Re: Shepherdstown Opera House Renovation

ADDENDUM No. 5

The following information amends or supersedes the current issue of architectural, structural, and MEP drawings/specifications dated June 22, 2020 and addendums #1, #2, #3 and #4.

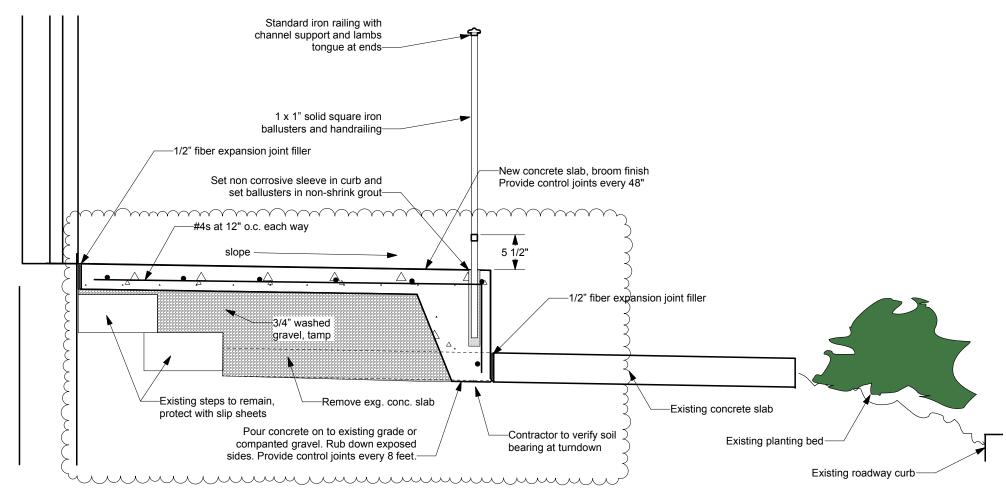
- 2. Is there a footing required under the first floor corner porch post? Yes, provide F2.5 concrete footing for this application.
- 3. Is a turn down "cheek wall" permitted at the entry slab and stair and if so what thickness and depth is required? See attached revised detail 5/A6.2 of the entry landing. Reinforcement would apply to the steps as well.
